CLARIFICATION NO. 1

**RFP TO OPERATE CONCESSIONS ON THE CHICAGO RIVERWALK
SPECIFICATION NO. 1256775**

**Chicago Riverwalk
SPECIFICATION No. 1256775**

SHEET NO.
A2.2

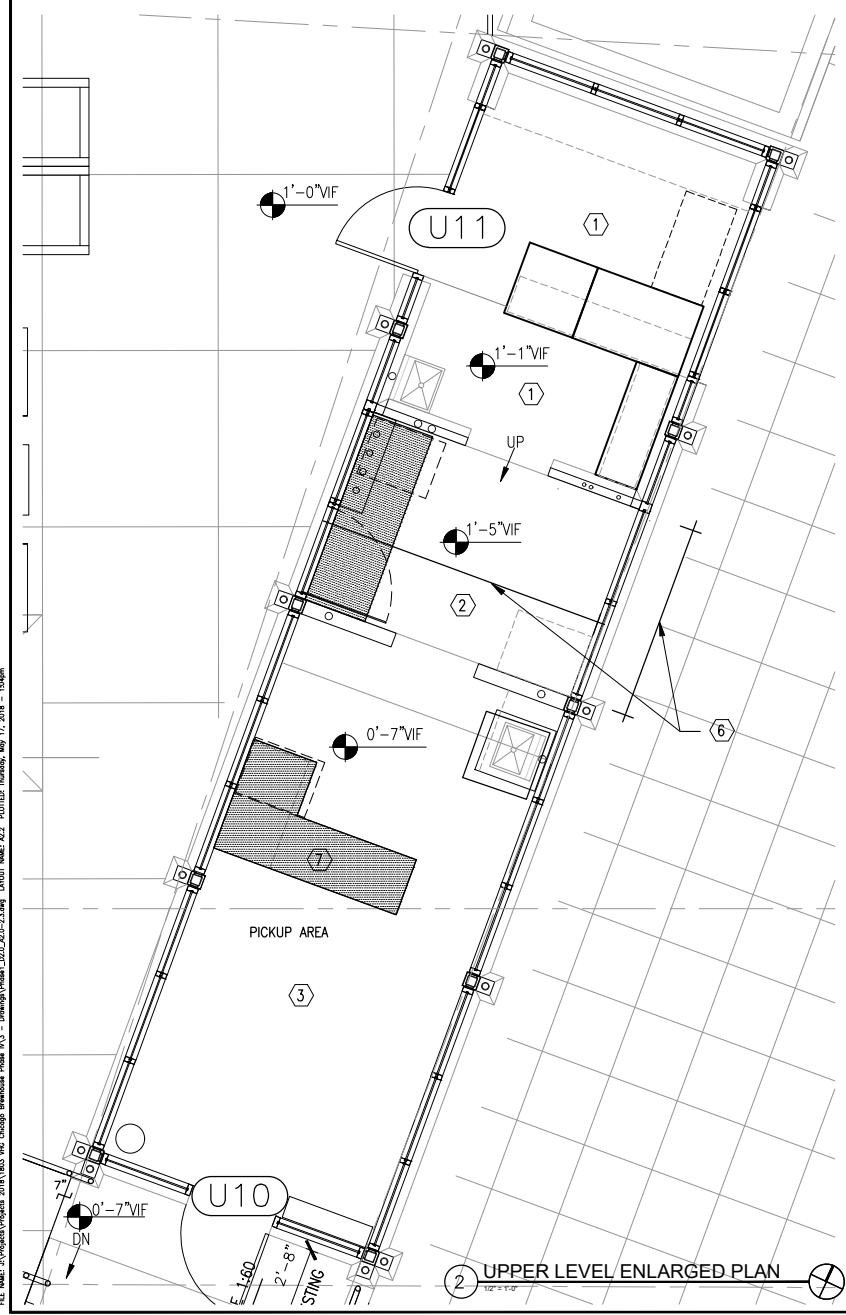
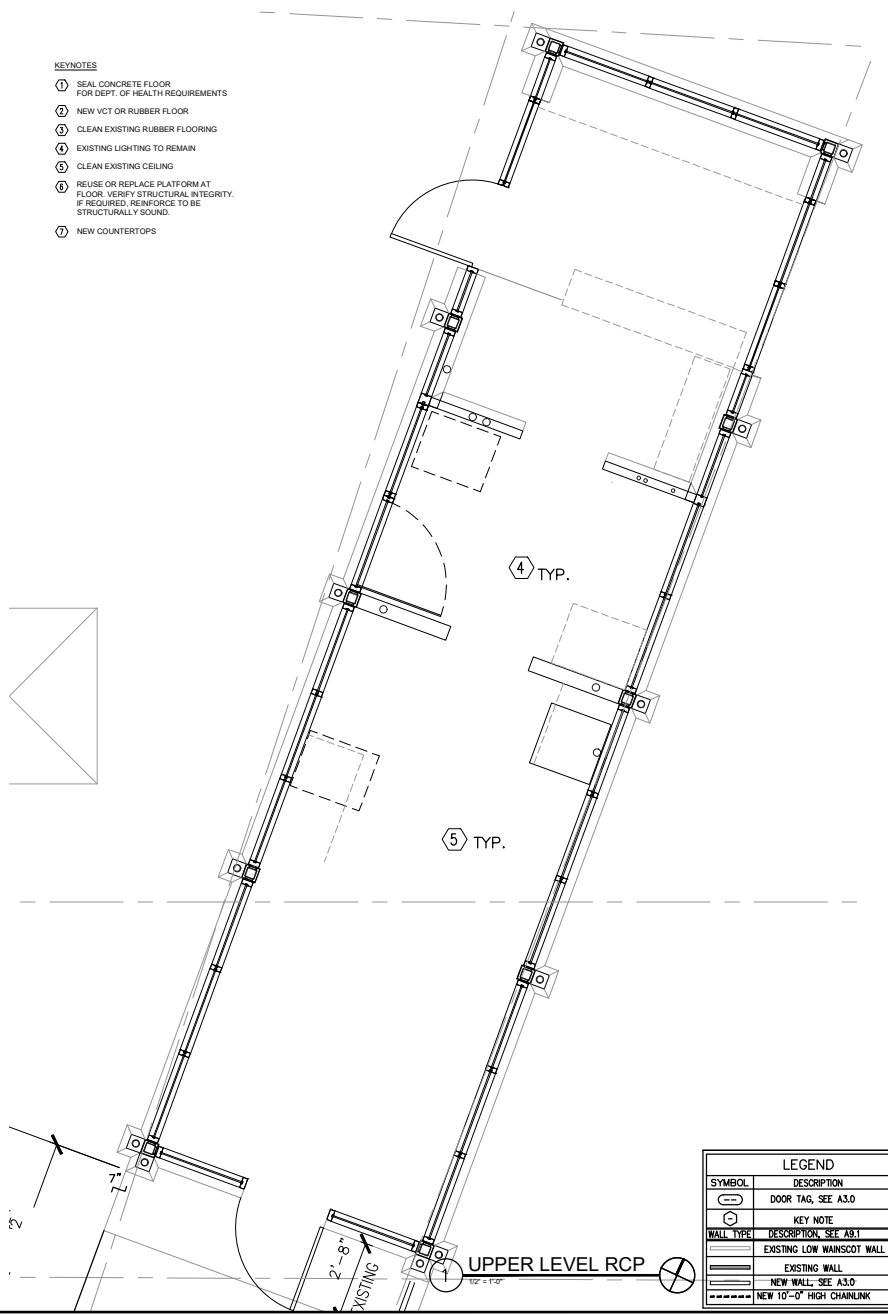
- 4. What are the dimensions for the upper-level space located at 376 North Wabash?**

The upper-level kiosk was constructed as part of the East-West Wacker Drive Improvement project constructed by the Chicago Department of Transportation. Vaughn's Hospitality Group held a license agreement to program the space since 2018. Attached please find a drawing they used for site improvements.
